# Access Compliance Report

## Public Rights-of-Way

Intersection ID: 22449	Main Street: ST_JOHN_LN	Cross Street: SHARON_HILLS_RD	Location: NE
ADA ID: 1967AC08C7BC	Ramp Type: PerpDiag	Initial Pass/Fail: Fail	Overall Compliance: No
		Severity Score: 10

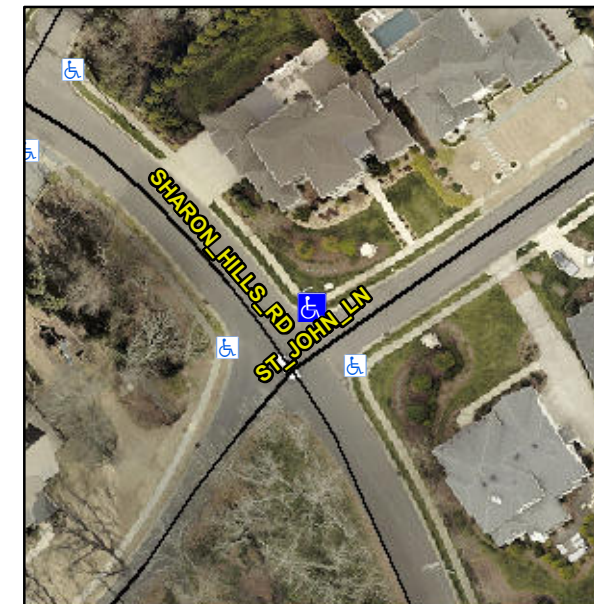
**Not Found, R304.5.1, R304.5.3**

Compliance	Description	Data	Compliance	Description	Data
N/A	Ramp Length (in)	97.0	Yes	Ramp Slope (%)	7.3
No	Ramp Width (in)	47.0	No	Ramp XSlope (%)	2.8
N/A	Flare Type LT	N/A	N/A	Flare Type RT	N/A
N/A	Flare Slope LT (%)	N/A	N/A	Flare Slope RT (%)	N/A
N/A	Flare Traversable LT?	N/A	N/A	Flare Traversable RT?	N/A
N/A	Landing Length (in)	N/A	N/A	DWS Provided?	N/A
N/A	Landing Width (in)	N/A	N/A	DWS Contrast?	N/A
N/A	Landing Slope (%)	N/A	N/A	DWS Length (in)	N/A
N/A	Landing X Slope (%)	N/A	N/A	DWS Full Width?	N/A
N/A	Landing Curb? (Y/N)	N/A	N/A	DWS Offset (in)	N/A
N/A	Shared Landing?	N/A			
N/A	Gutter Ponding?	N/A	N/A	Gutter Slope (%)	N/A
N/A	Gutter Lip Ht (in)	0.5	N/A	Gutter X Slope (%)	N/A
N/A	Painted X Walk1?	No	N/A	Painted X Walk2?	No
	X Walk 1 Direction	To W		X Walk 2 Direction	To S
N/A	X Walk 1 Width (in)	N/A	N/A	X Walk 2 Width (in)	N/A
	X Walk 1 Slope (%)	1.8		X Walk 2 Slope (%)	2.5
	X Walk 1 X Slope (%)	4.1		X Walk 2 X Slope (%)	1.6

**Remove & Replace Curb Ramp With Two New Directional Ramps or Equivalent.**
